TOWNSHIP OF FRANKLIN
Planning Board
Agenda
Wednesday, March 4, 2026

CONCORE REALTY, LLC / PLN-23-00006

Preliminary & Final Major Subdivision w/C Variances in which applicant seeks approval to construct a 15,425sqft warehouse at 403 Elizabeth Avenue, Somerset; Block 502.02 Lot 9.01 in zone B-I

PRELIMINARY/FINAL SITE PLAN
for

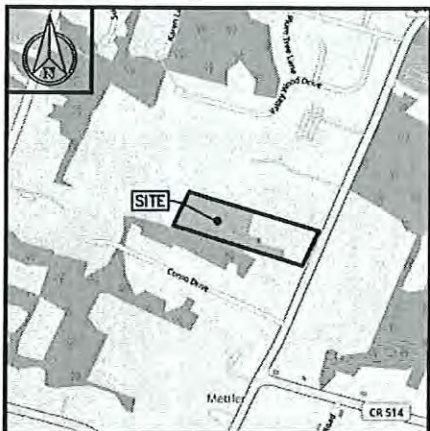
- Road to be private
- Basin maintained by HOA
- porous point for residential driveways is not realistic
